**PLANNED UNIT DEVELOPMENT
& SUBDIVISION STAFF REPORT****Date: July 5, 2012****SUBDIVISION NAME**

Highland Professional Park Subdivision, Re-subdivision of Lots 2 & 3, Resubdivision of Lot 2B

Planned Unit Development Approval to amend a previously approved Planned Unit Development to allow shared access between multiple building sites and Subdivision approval to shift an interior lot line between two legal lots of record.

SITE PLAN

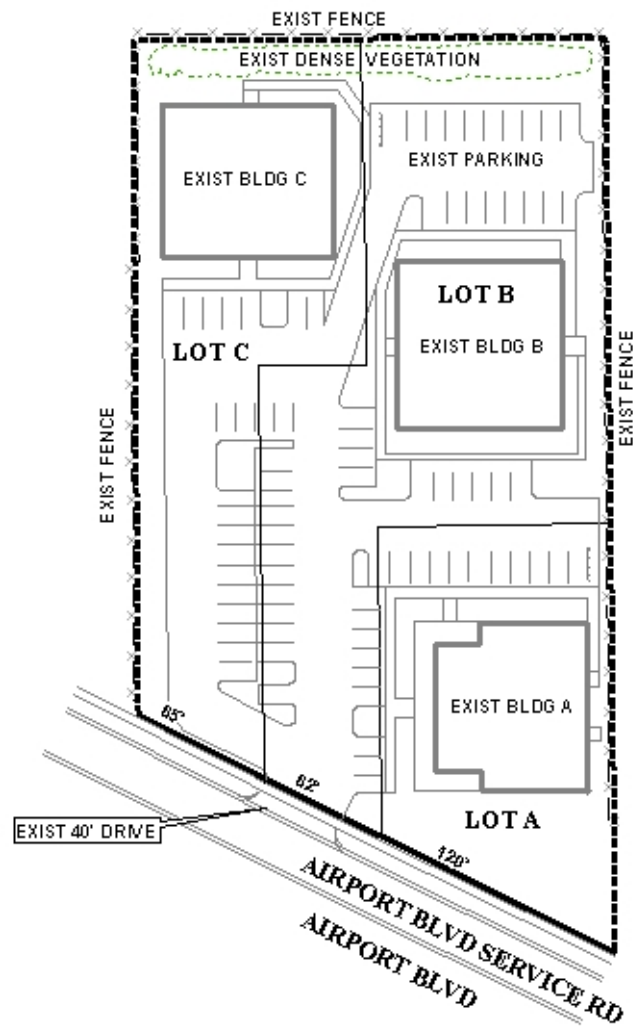
The proposed site plan illustrates the existing buildings with the proposed addition of the parking areas and the location of the dumpster: it should be noted that ALL dumpsters/compactors must meet the buffer requirements of the Zoning Ordinance and be screened with a minimum six-foot solid privacy fence. Also, since the site is adjacent (North and East) to residentially zoned properties, compliance with Section 64-4.D.1., would be required.

The plat and site plan show a 15-foot wide buffer, which was required when the site was originally developed. This buffer should be shown on the Final Plat and site plan if approved.

- 1) limited to the site plan submitted, any significant modification will require new application(s) to the Planning Commission;
- 2) provision of the 15' buffer and 6' privacy fence along the East property line, as shown on the plan submitted (and required by the original approval), buffer area to be landscaped;
- 3) compliance with Sections 64-4.A.2 and 64-6.A.3.C of the Zoning Ordinance;
- 4) compliance with the tree and landscaping requirements of the Zoning Ordinance for new construction; and
- 5) full compliance with all municipal codes and ordinances.
